DEVELOPMENT SERVICES COUNCIL REPORT

File No: DP 22-20

Subject: **DP 22-20; Development Permit with Variances; 2102 Shannon Ridge Drive)**

Figure 1 – Site plan showing development concentrated on the top of the site to retain natural vegetation, and landscaping throughout the development.

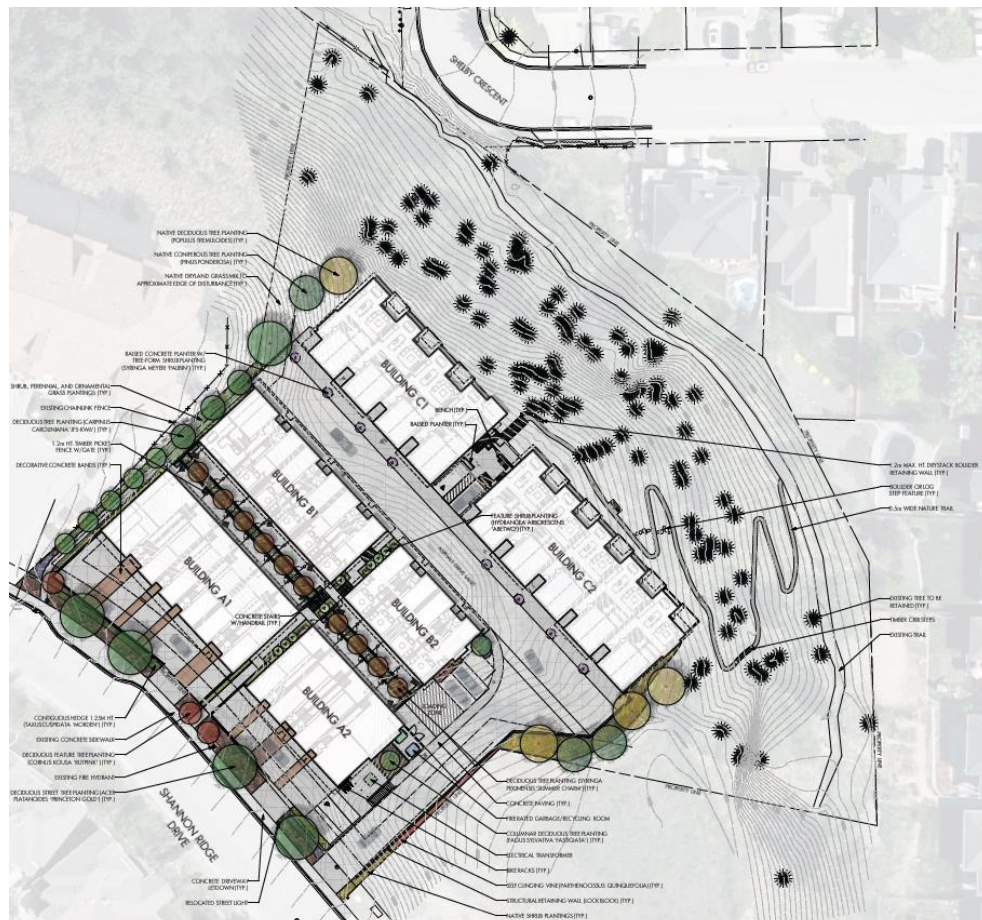
The subject property is subject to the General Development Permit Guidelines. The proposal meets the Guidelines. Key highlights include:

- Landscaping is provided on private property to respect and improve the streetscape and public realm (Guideline s.4.2.12.1.)
- Environmental features such as mature stands or trees and existing native vegetation is protected (Guidelines s.4.2.5.7. and s.4.2.5.8.)

Figure 6 – Highest building on site (Block C2) facing treed covenant area.

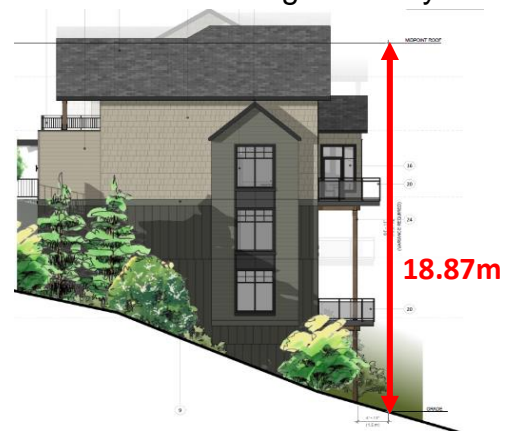
The proposed height variance from 12m to a maximum of 18.87m effects buildings A1, A2, C1, and C2. The highest height is for block C2 which has a max height of 18.87m at the rear (Figure 6). All blocks (A - front, B - middle, and C – rear) meet the height requirement of 12m, up to three stories, when viewed from Shannon Ridge Drive, and all parts of Block B are under 12m. The variance from 3 stories to four stories is for the townhomes at the rear of the site. The fourth story is a mezzanine space above the garages. For more information on the heights/storeys refer to Sheet A1.2 and A1.3 of the Architectural Drawings found in Attachment 1.

This variance is supported as the highest part of the development is adjacent to the protected area and will be screened by existing vegetation. The increase to four stories is only for mezzanine spaces in the rear block which improves the form and character of the development from Shannon Ridge Drive (Figure 7).

Figure 8 – Left: reduced interior side setback to 2.83m (3m building setback with 0.17m for a pop-out). Right: proposed 0.17m pop-out.

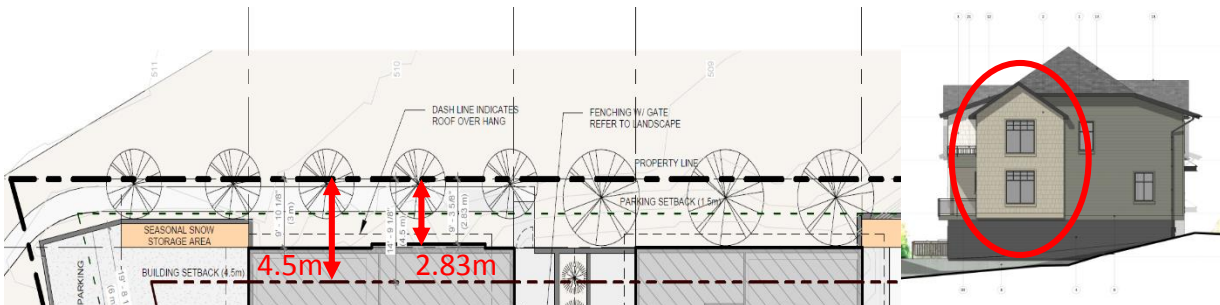
The R4 Zone requires a 4.5m setback from the interior side parcel boundary. The applicant has instead proposed the 3.0m setback requirement found in the R3 Zone. An additional 0.17m setback is proposed to allow for a pop-out (Figure 8). The pop-out meets the Zoning Bylaw siting exemption requirements of extending no more than 0.6m into the proposed 3m interior side setback and not taking up more than 35% of the building face.

This variance is supported as the setback proposed is the requirement used for townhomes elsewhere in the City in R3 Zones. Although this property is zoned R4, the proposal matches the R3 Zone use (townhomes) and lower density (0.6 FAR) making the smaller setback reasonable for this development. The proposed pop-out adds architectural detail to the development aligning with development permit guidelines and meets siting exemptions in the Zoning Bylaw.

Figure 9 – Reduced two-way drive aisle width to make room for loading spaces, internal street trees, and space for pedestrians. 7.5m of functional space is provided for vehicles moving in and out of parking spots.

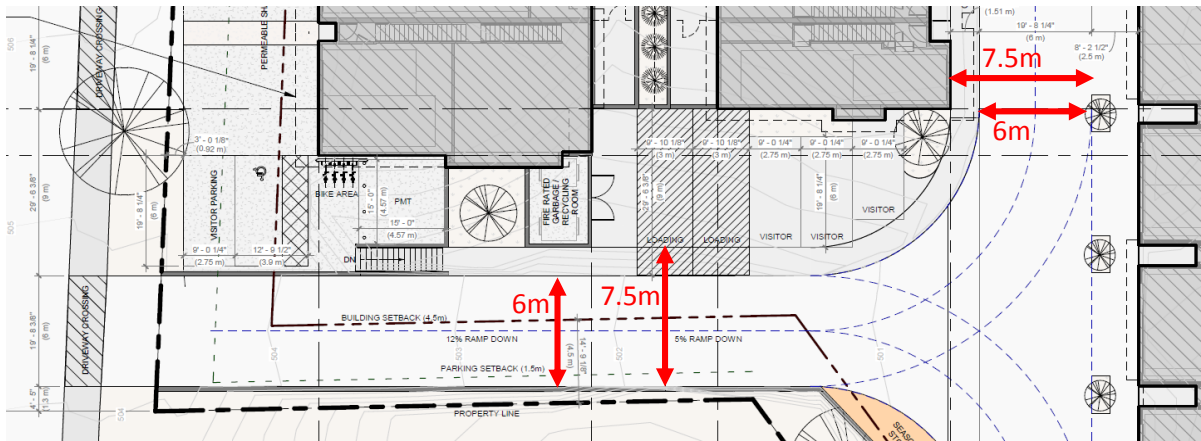
The intent of the minimum 7 meter two-way access aisle requirement is to ensure adequate space for the maneuvering of vehicles in and out of parking spaces. The main two-way drive aisle provided is 6 meters. As shown, 7.5 meters is available for vehicles when moving in and out of parking spaces (Figure 9).

This variance is supported as it allows room for a loading area, internal street trees, and space for pedestrians aligning with development permit guidelines. The drive aisle remains usable for vehicles with adequate space provided for moving in and out of parking spaces.

Figure 10 – Parking stalls shown adjacent to the front parcel boundary and screened from Shannon Ridge Drive by landscaping in the right of way.

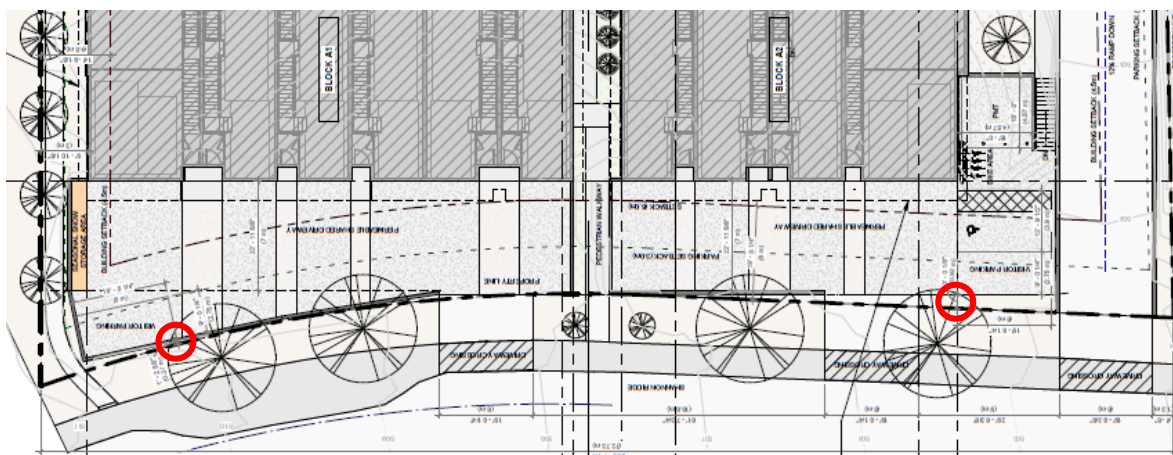
The minimum setback requirement of 3.0m for parking is to limit visibility of parking areas from the street and provide space for landscaping. The parking stalls are located closer to the front parcel boundary (max 0.37m) but are screened by approx. 3 meters of landscaping in the right of way (Figure 10).

This variance is supported as the applicant is providing approximately 3 meters of landscaping in the right of way to screen the parking area.
